Our Case Number: ABP-314942-22

Re: BusConnects Lucan to City Centre Core Bus Corridor Scheme
Lucan to Dublin City Centre

SUBMISSION IN RESPECT OF
THE LUCAN TO CITY CENTRE BUS CORRIDOR

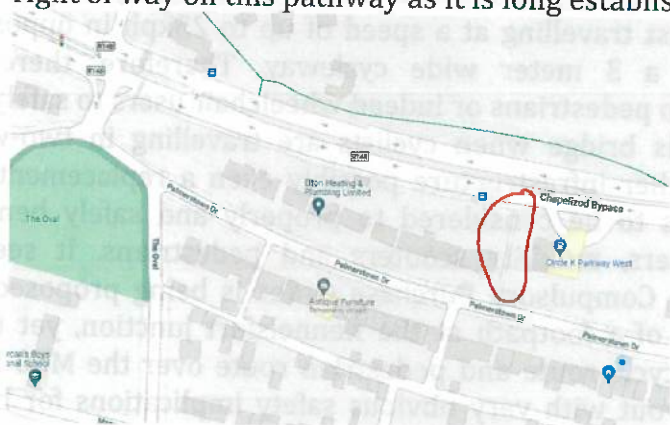
5. The existing pedestrian and cycle bridge across the M50, shown on sheet 11 (see below) is simply not wide enough for a two way cycle lane and a two way walkway proposed. Considering the distance recommend leaving a cyclist by a car in zones up to 50km is one meter (www.rsa.ie) this would seem to mean two cyclist travelling at a speed of up to 25kph in opposite direction would need a 3 meter wide cycleway. Therefore, there is insufficient room for two pedestrians or indeed wheelchair users to safely to pass each other on this bridge when cyclists are travelling in two-way directions. As such further infrastructure possibly even a replacement or additional bridge needs to be considered to properly and safely benefit cyclists, wheelchair users, mobility scooters and pedestrians. It seems disproportionate that a Compulsory Purchase Order is being proposed to straighten a few yards of a footpath at the Kennelsfort junction, yet it is proposed to leave the cycle route and pedestrian route over the M50 in a very poor zigzagging layout with very obvious safety implications for both pedestrians, cyclists and wheelchair/mobility scooter users.
